FOUNDATION INVESTIGATION REPORT
For
Proposed Twin Overpass Structures
At the Crossing of Hwy. 427
And Woodbine Racetrack Entrance Road
Borough of Etobicoke, County of York
District No. 6 (Toronto)
W.O. 72-11023 -- W.P. 48-71-02

ADDENDUM TO THE
FOUNDATION INVESTIGATION REPORT
For
Proposed Hwy. #427 Overpass at Woodbine
Racetrack Entrance Road
Borough of Etobicoke, County of York
District #6 (Toronto)
W.O. 72-11023 -- W.P. 38-71-02
48

Re: Hwy.427 Overpass at Woodbine
Racetrack, Entrance #1,
W.P. #48-71-02, Site #37-983
Highway #427, District #6, Toronto

DISTRICT 6
 CONT No
 No 48-71-02
 HWY 427 OVERPASS AT WOODBINE RACETRACK ENTRANCE #1
 GENERAL DRAWING

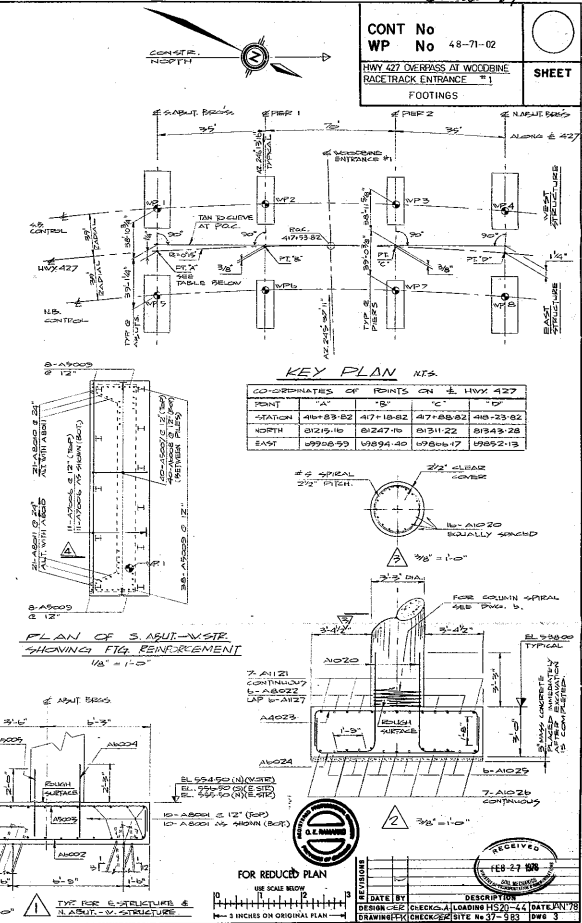
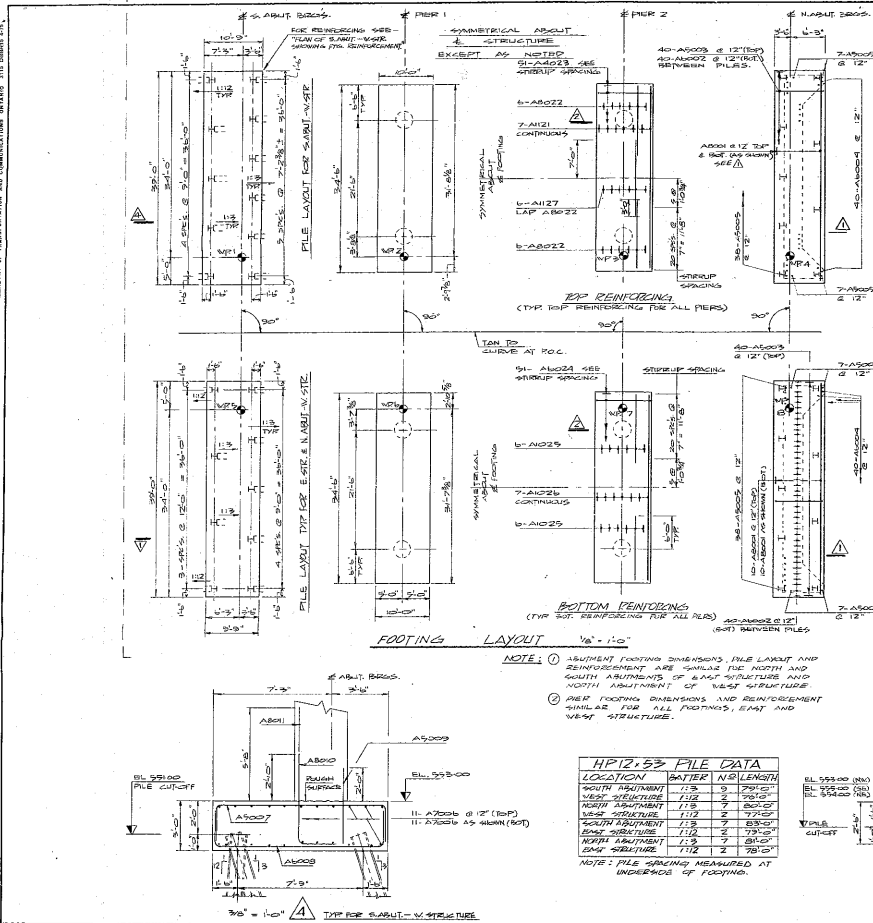
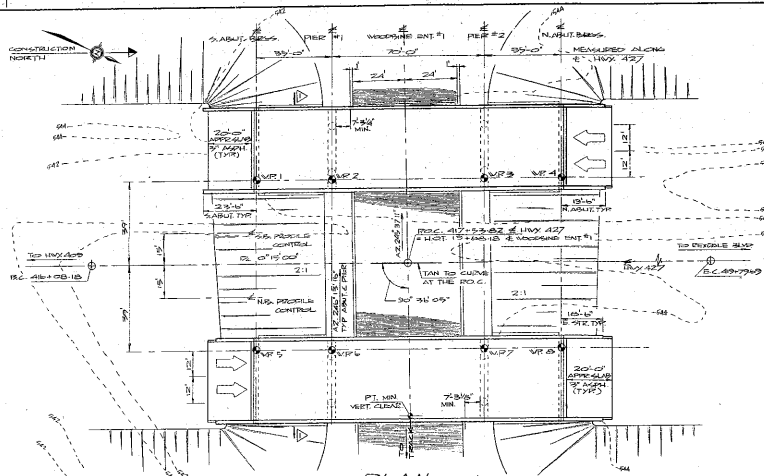
We have reviewed the final bridge plan drawings (Drawing #1 and #3) dated January 1978, for the above mentioned structure and have the following comments.

1. The piers are founded on spread footings at about elevation 535.0. At this elevation a safe bearing value of 2.5 t.s.f. is recommended.
2. In our letter dated November 2, 1977 we recommended the support of perched abutments in the approach fills, placed on a core of well compacted granular "A" material with 2.5 t.s.f. design load. Alternatively, we recommended a #14 timber pile support driven to tip elevation 520.0 with a safe load of 25 tons/pile. According to the final plan drawings, the abutments are supported on 12 HP53 steel H-piles driven to bedrock. However, the final choice should be based on economic or other necessitating considerations.
